RESERVE @ MITCHELL MILL
TOWN OF ROLESVILLE, WAKE COUNTY, NORTH CAROLINA
CONSTRUCTION PLANS
ZONING CONDITION

RESERVE @ MITCHELL MILL
TOWN OF ROLESVILLE, WAKE COUNTY, NORTH CAROLINA
CONSTRUCTION PLANS

RESERVE @ MITCHELL MILL
TOWN OF ROLESVILLE, WAKE COUNTY, NORTH CAROLINA
CONSTRUCTION PLANS
PARTIAL SITE PLAN VIII

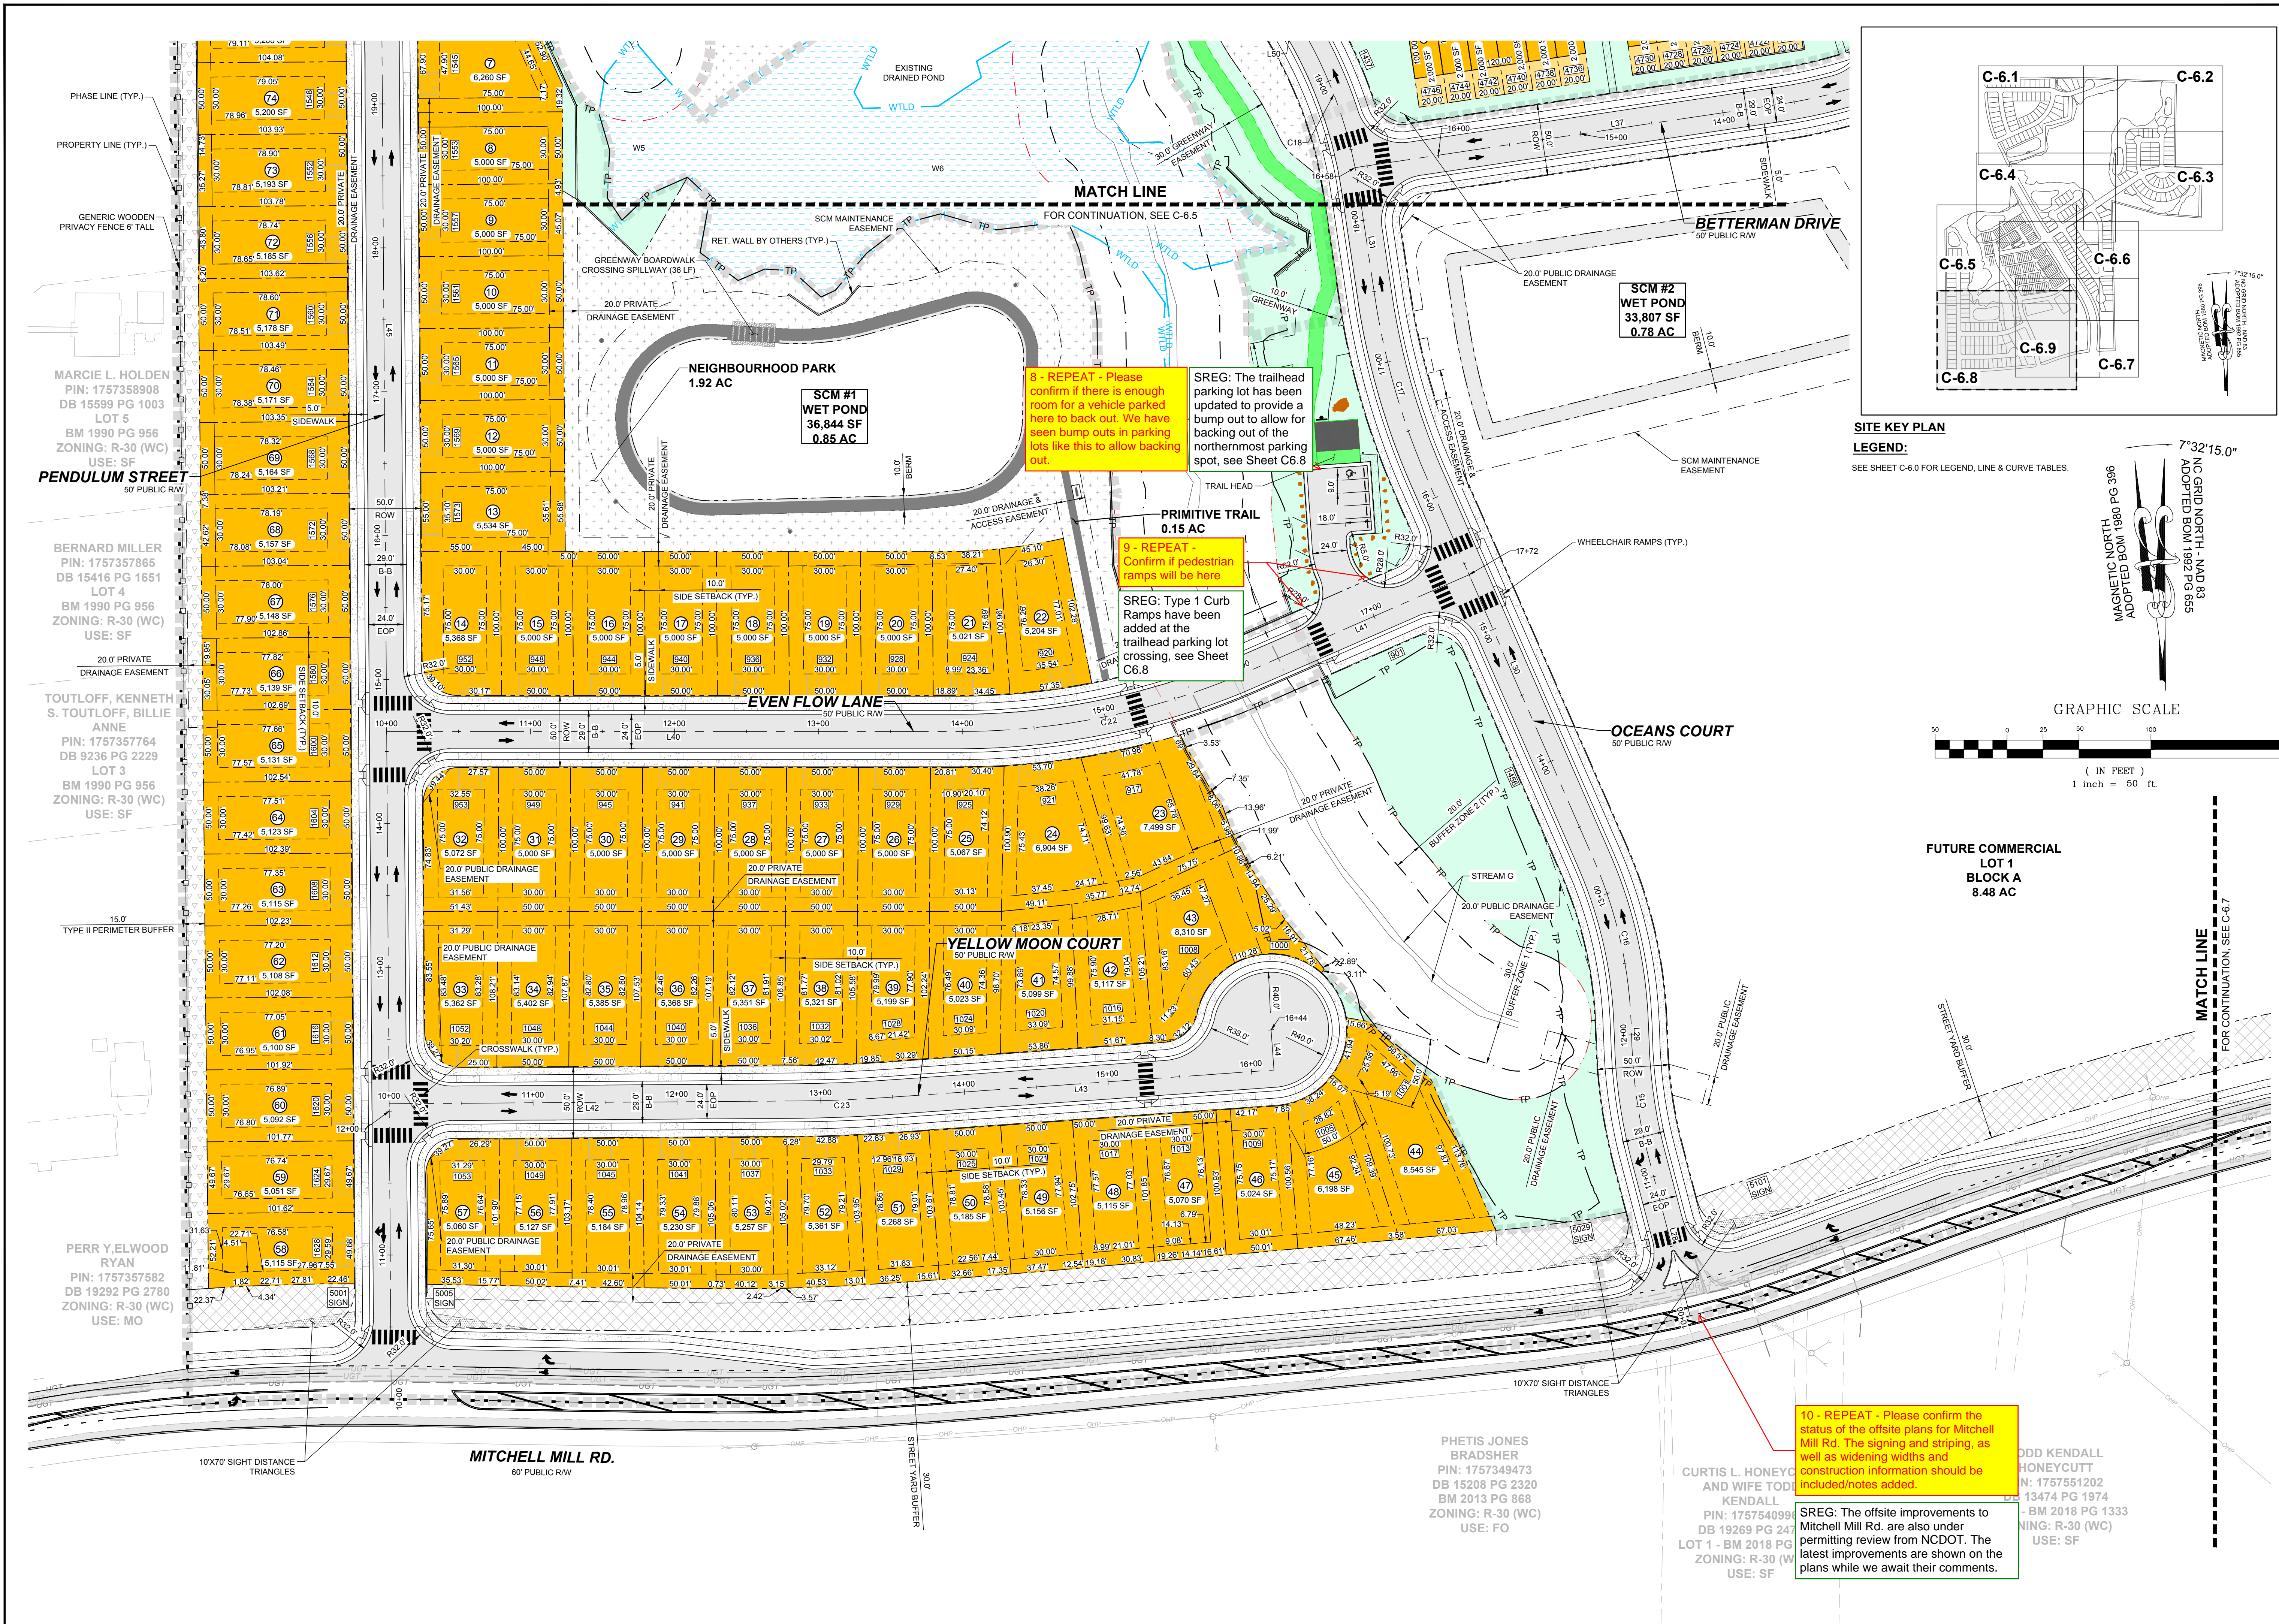
9 - REPEAT - Confirm if pedestrian ramps will be here

10 - REPEAT - Please confirm the status of the offsite plans for Mitchell Mill Rd. The signing and striping, as well as widening widths and construction information should be included/notes added.

SREG: The trailhead parking lot has been updated to provide a bump out to allow for backing out of the northernmost parking spot, see Sheet C6.8

SREG: Type 1 Curb Ramps have been added at the trailhead parking lot crossing, see Sheet C6.8

SREG: The offsite improvements to Mitchell Mill Rd. are also under permitting review from NCDOT. The latest improvements are shown on the plans while we await their comments.
